STAFF RECOMMENDATION

**1101 Porter Road
January 20, 2021**

Application: New Construction—Addition
District: Eastwood Neighborhood Conservation Zoning Overlay
Council District: 06
Base Zoning: R6
Map and Parcel Number: 08303018500
Applicant: Jon Wagenman, Owner
Project Lead: Sean Alexander, sean.alexander@nashville.gov

SHEET TITLE: DEMOLITION FIRST FLOOR PLAN

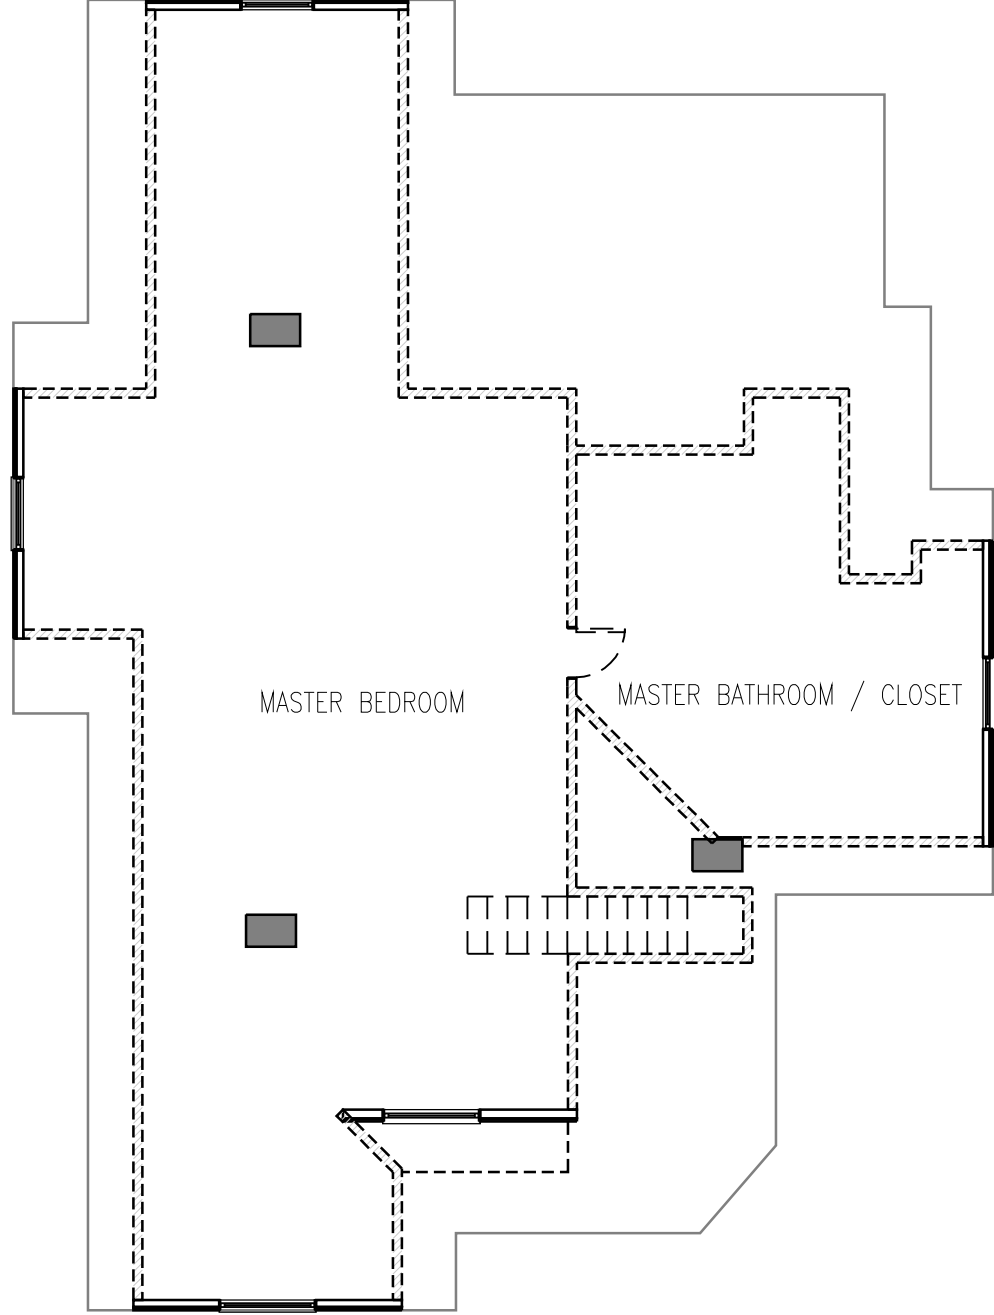
Demolition: The project involves demolishing the previous addition and portions of the existing rear wall and rear roof slope of the building to accommodate the new addition. These portions of the building are visible from Rosebank Avenue because of the house's corner location but would not be visible on a typical mid-block lot. The portions to be removed do not contribute to the historic character of the house.

A window toward the rear of the left elevation will be replaced with a pair of windows, matching the original window height and doubling the width of the opening. Staff finds the window replacement does not negatively impact the historic character of the house because of its location at the rear and the similarity in size.

ROOF PLAN

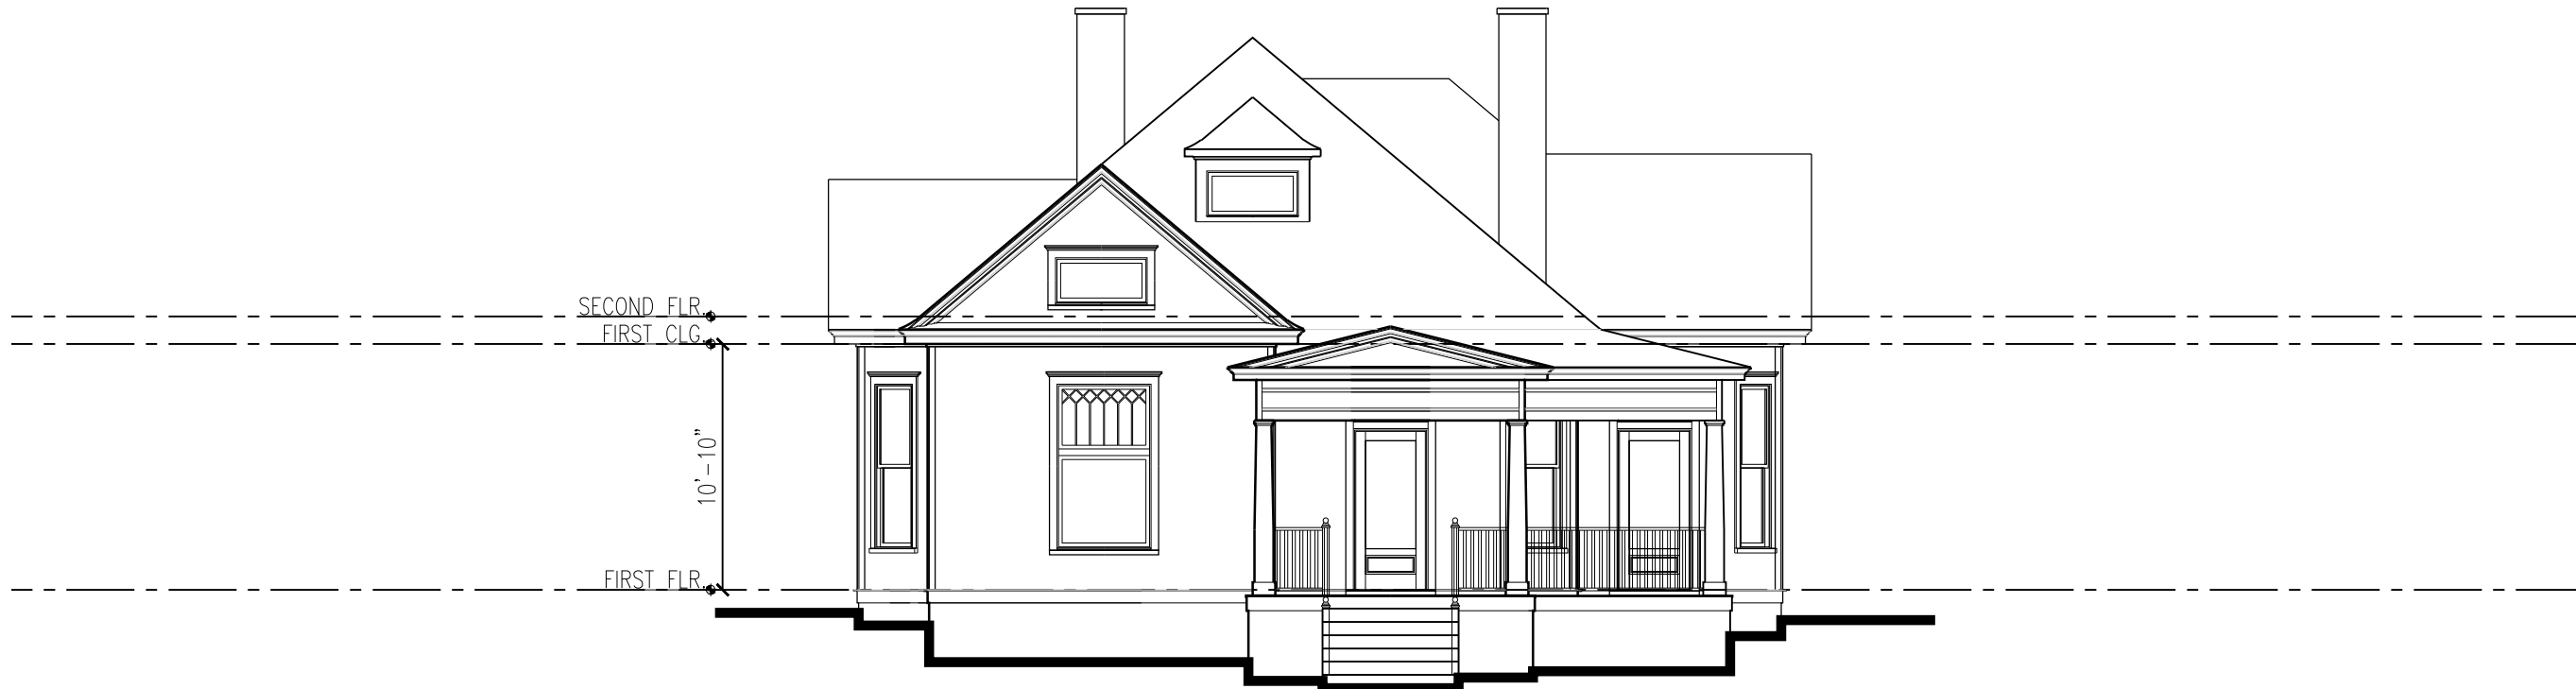
Roof form: The roof of the addition will tie into the primary ridge and left side hip-ridge of the primary roof and extend back, matching the existing pitch and hipping at the rear. On the right side the addition's roof will be stepped down from the existing hip-ridge and right side slope.

Additions to hip-roofed houses previously have been required to step in from the side slopes in order to differentiate the new construction from the historic, and to leave the historic hip-ridges intact.

A hipped roof dormer will be added on the left side slope of the hipped roof, roughly at the midpoint of the primary roof mass. This is an appropriate location for a dormer addition.

With a condition that the roof of the addition is stepped down from the primary roof-ridge and the hip-ridge is stepped in at least six inches (6") on the left side of the historic house, Staff finds that the roofs of the addition are appropriate and meet Section II.B.1.e. of the Design Guidelines.

1. The roof of the addition is stepped down from the primary roof-ridge and the hip-ridge is stepped in at least six inches (6") on the left side of the historic house; and
2. The window and door selections are approved prior to purchase and construction.

DATE:	12/30/2020
DRAWN BY:	SLN
REVISION:	
SHEET TITLE:	ELEVATIONS

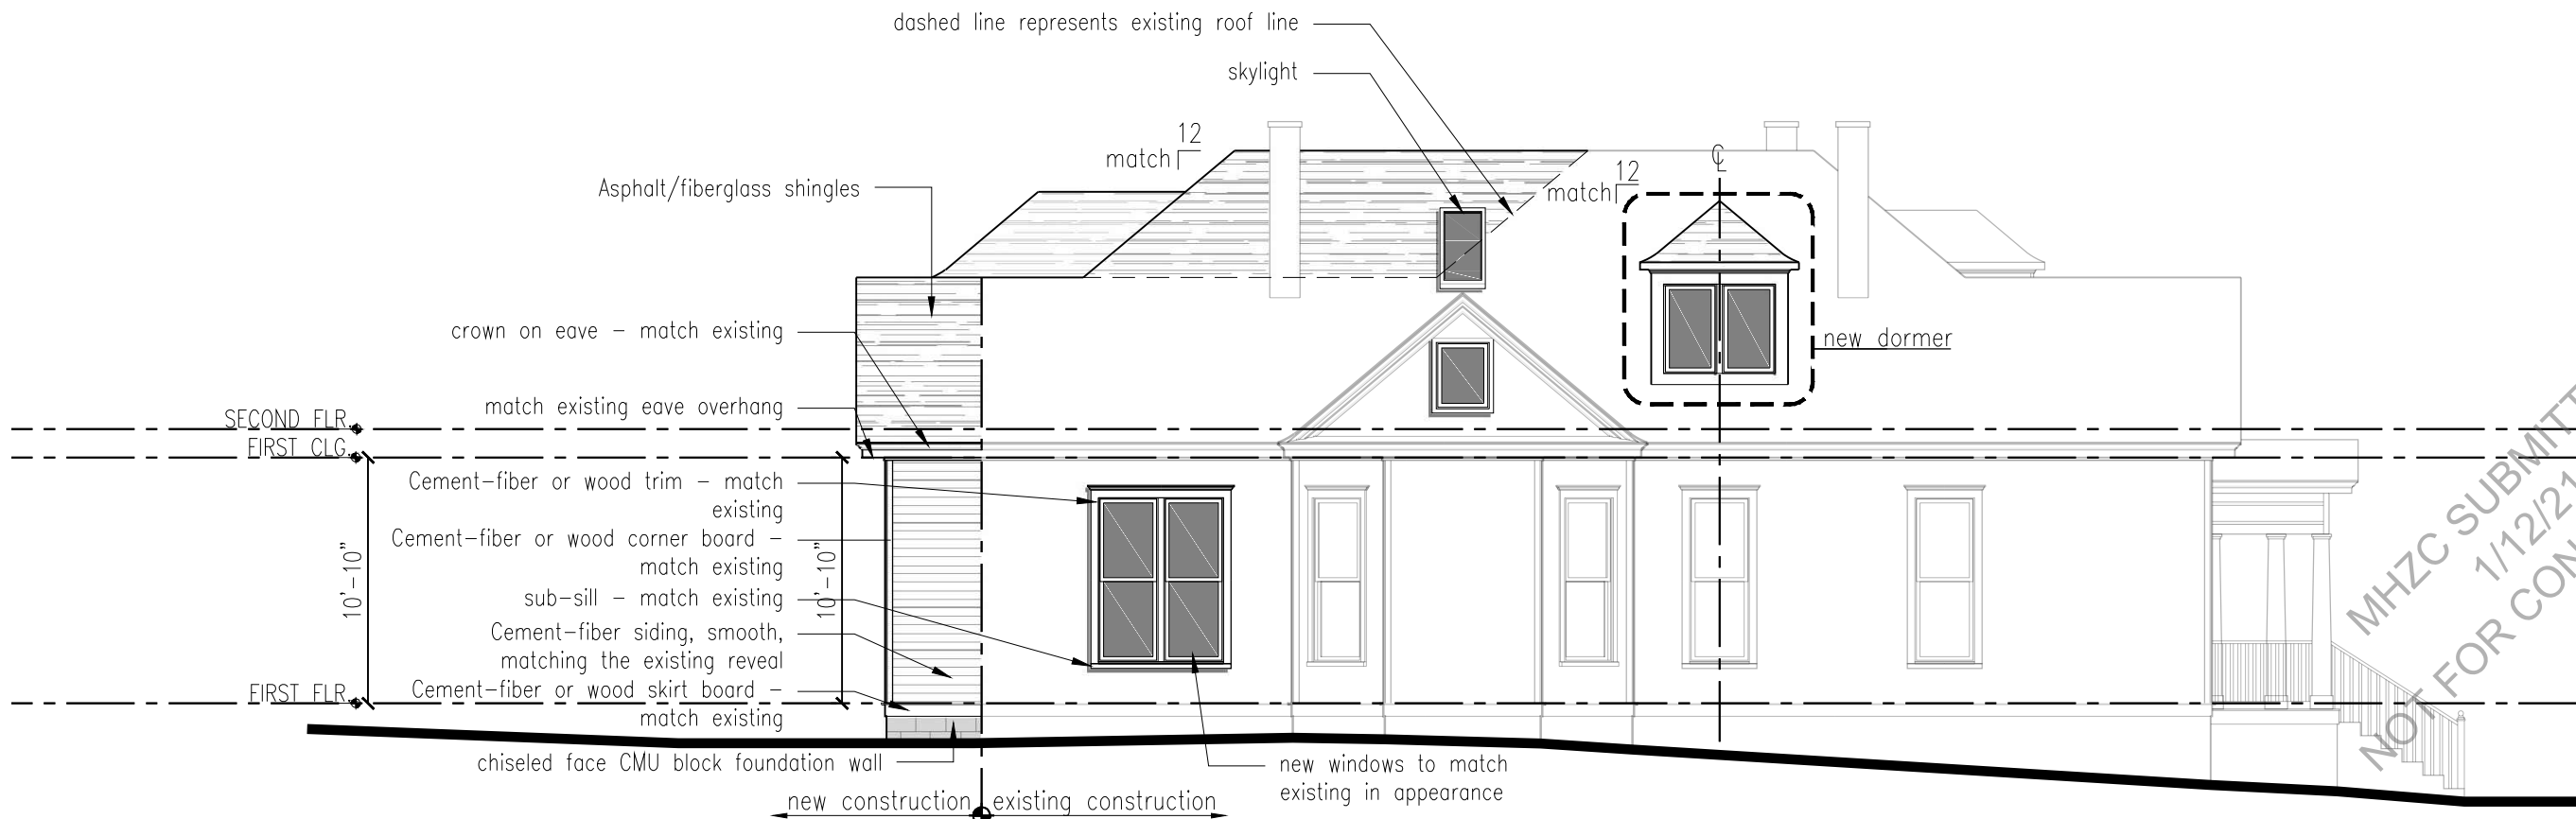
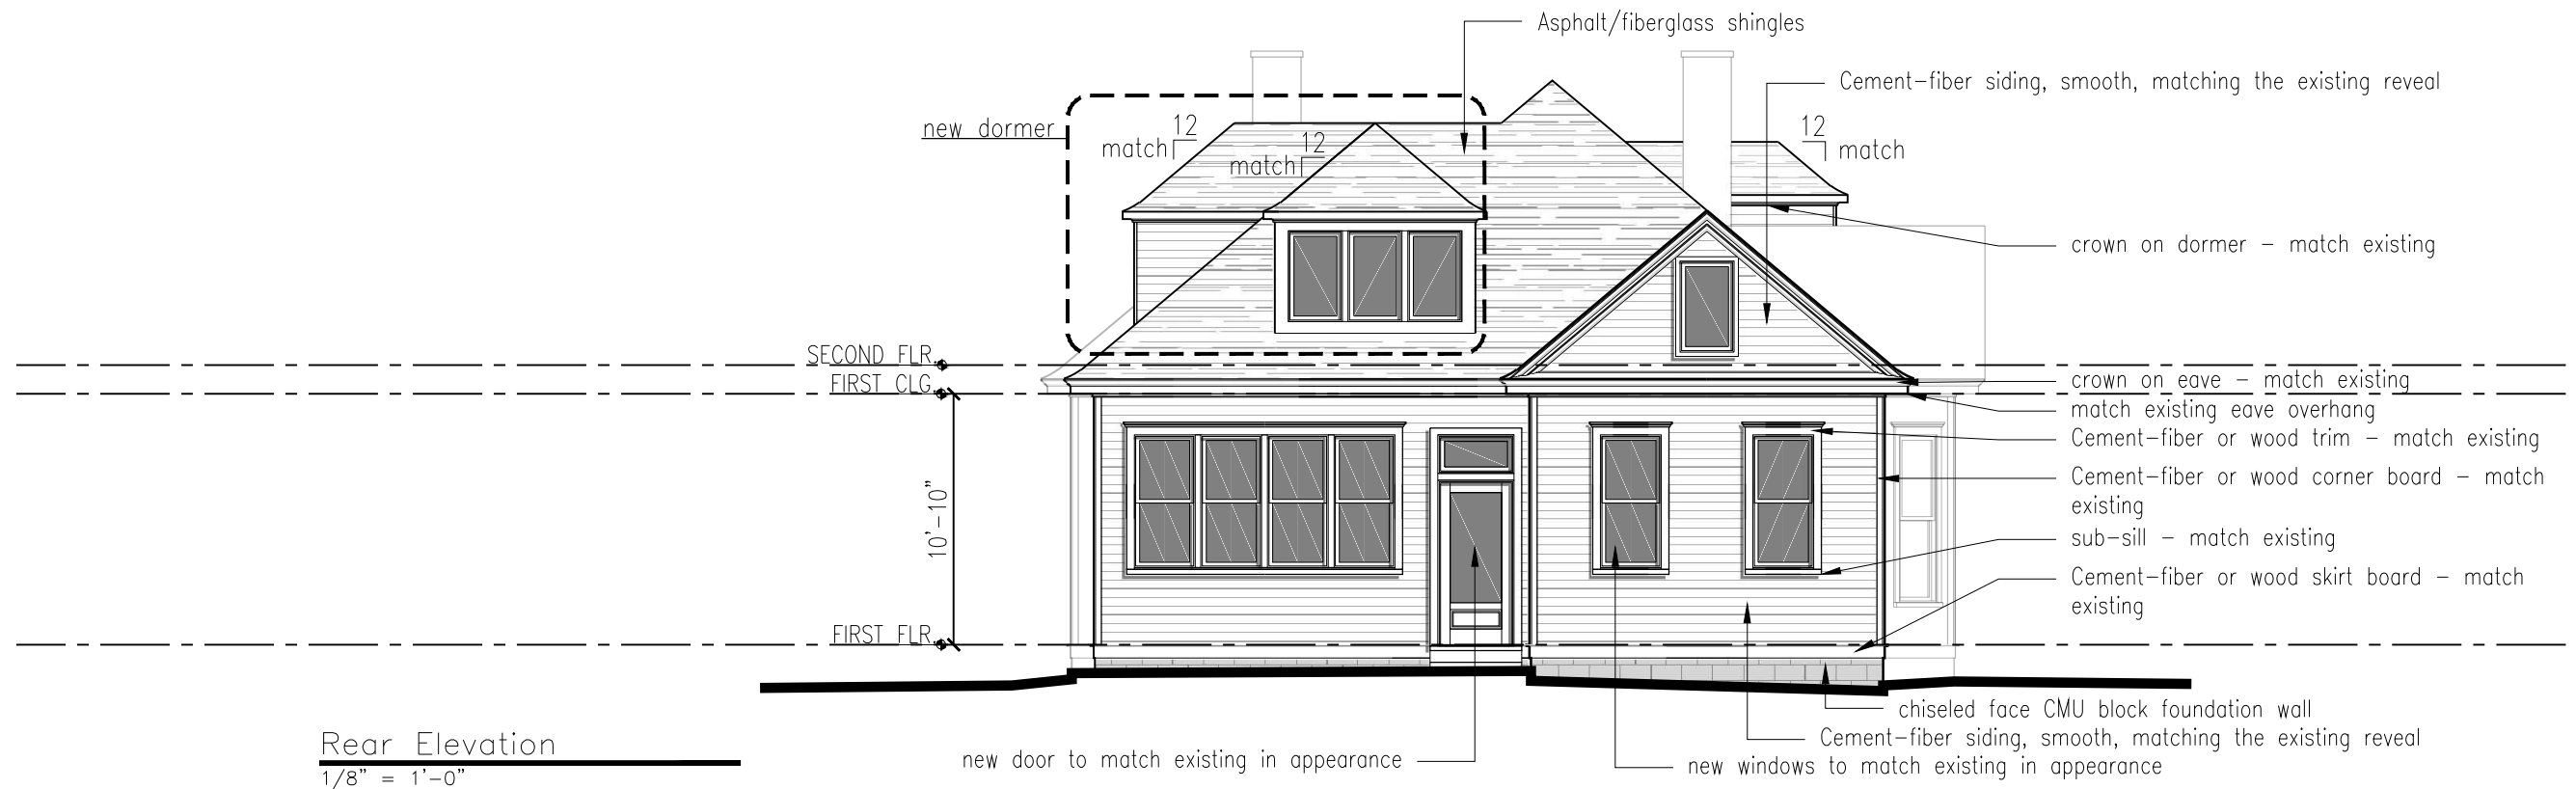
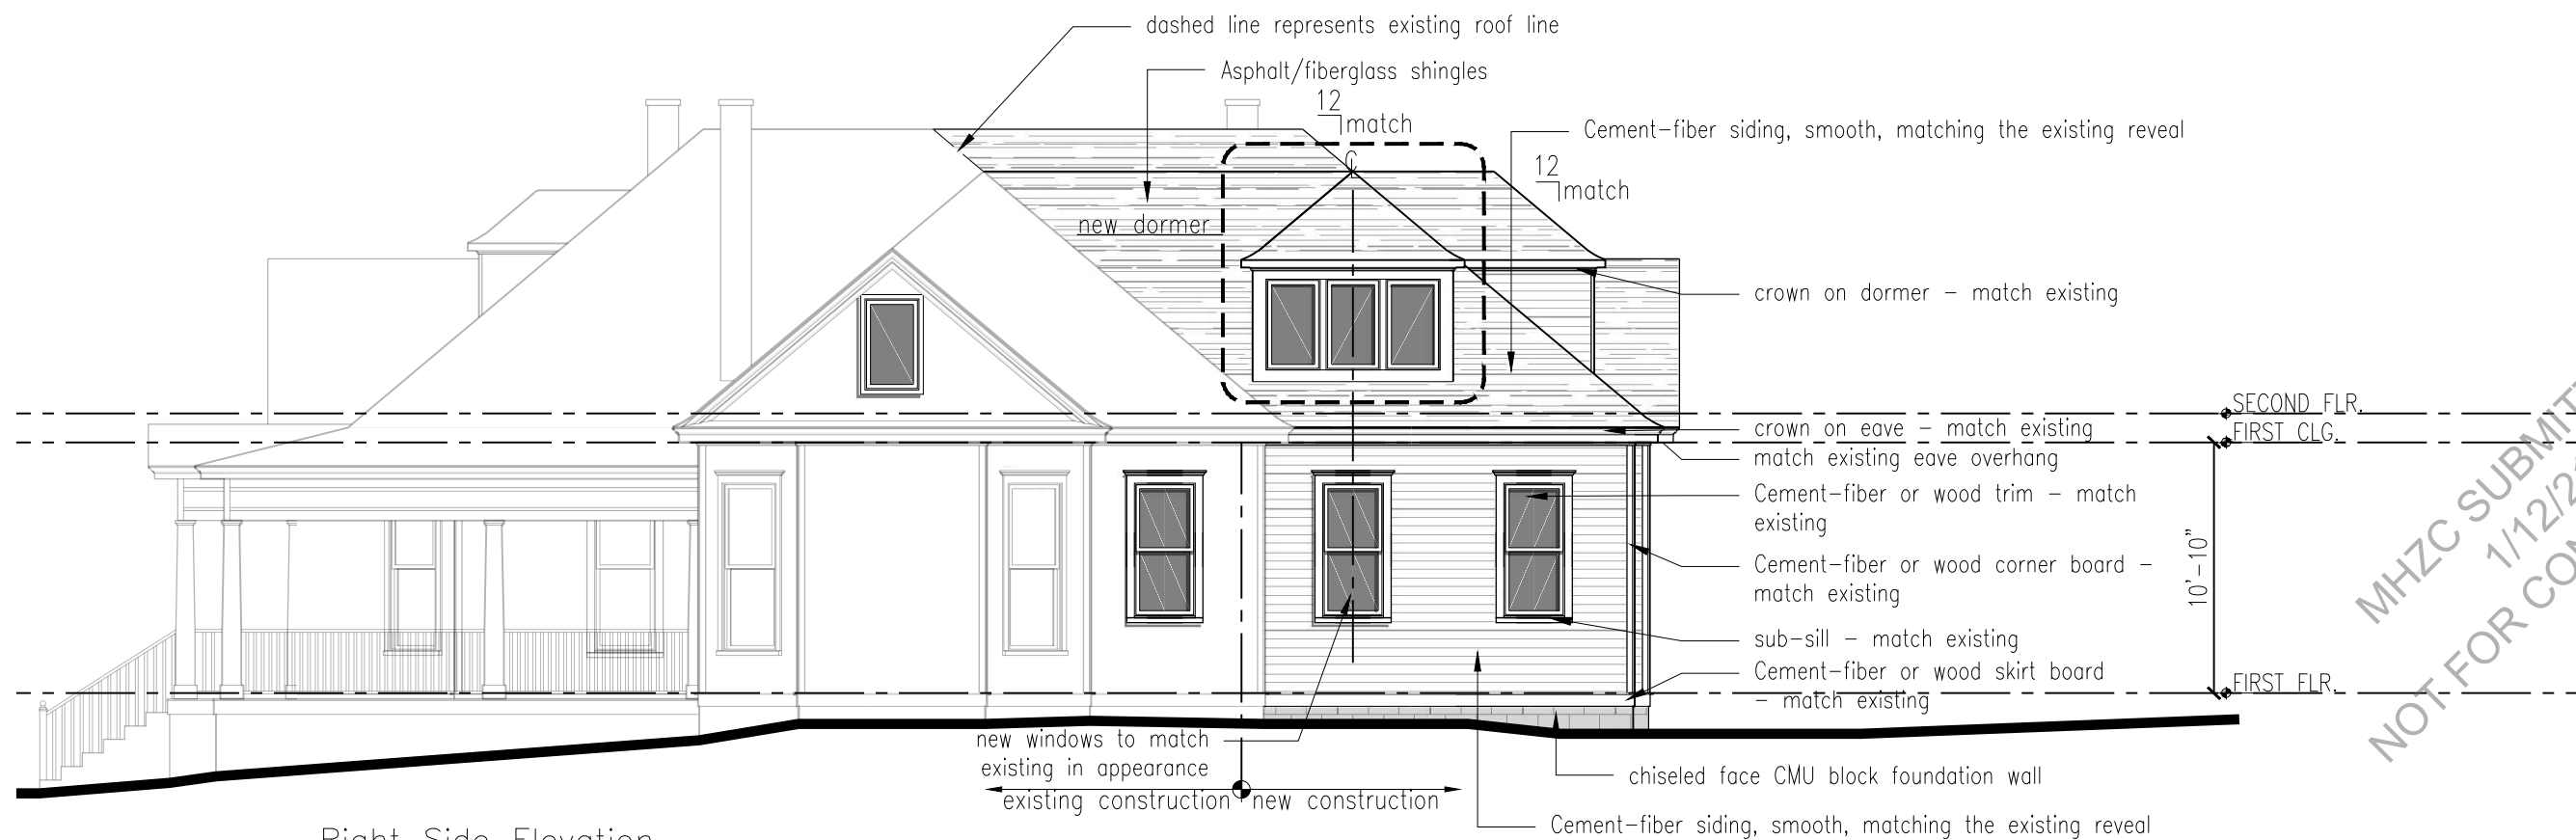
Location & Removability: The walls and roof of the addition are stepped in from the wall and roof of the historic house on the right side, but not on the left. Staff finds that an inset on the left wall is not necessary because the depth of the addition is minimal at only four feet (4'), but that there roof should be stepped in at least six inches (6") as is typically required.

Design: The character of the addition is compatible to the historic house in its detailing, with a similar roof shapes, window proportions, and matching exterior materials. The form of the addition will be distinguished from the original building by stepping in from the side walls before continuing back on the right side wall and roof.

Height & Scale: The proposed addition ties into the existing roof at the ridge and extends toward the rear. While the addition is not taller than the house, Staff recommends that the roof steps down from the primary ridge and in from the left hip-ridge where it attaches to the historic house in order to preserve the original form and differentiate the new construction. The connection of the addition's roof to the historic roof is stepped down on the right side, which is appropriate.

The addition steps in one foot (1') narrower than the historic house on the right side and matches the house's width on the left. Staff finds the widths to be appropriate. The addition adds only four feet, one inch (4'-1") to the depth of the house.
